REQUEST FOR INFORMATION

DATE: July 18, 2016 **NO.:** RFI-206

Project Name: 15051-Webster University Interdisciplinary Science Building Project No.: 15051

Subject: Slab on Metal Deck Pour break lines & Sequence

LEVEL 02 FLOOR FRAMING PLAN

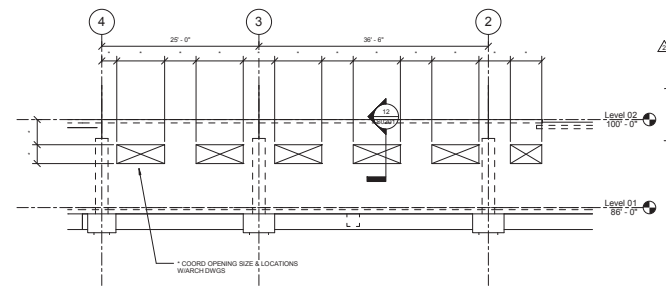
The Level 2, 3 and 4 slab on metal deck pours will be placed in 2 sequences – Area A and Area B. The break line between these pours will be approx. 3' west of 5 line (see attached sketch). Please confirm this is acceptable and please advise of a construction joint detail for slab on metal deck at these areas.

Additionally, the slab on metal decks will be placed in Area B while Area A structural steel is erected. The pour sequence will be Area B 2nd floor, Area B 3rd floor, Area B 4th floor, Area A 2nd floor, Area A 3rd floor, Area A 4th floor. Please advise if there are any building structural issues with this sequence.

Construction joint detail shown next sheet. Proposed sequencing will reduce the lateral loads that can be transferred into frame on Grid 5 and frame on Grid D will take no loads. The design of the building is for a completed construction. An analysis of the temporary conditions due to sequencing is not performed as part of our scope. The means and methods of bracing the building during construction for the potential loads it may experience is the contractor's responsibility. Temporary loads such as reduced wind loads and the risk associated with seismic during a short term are loads that should be considered in addition to stability of the frame in general.
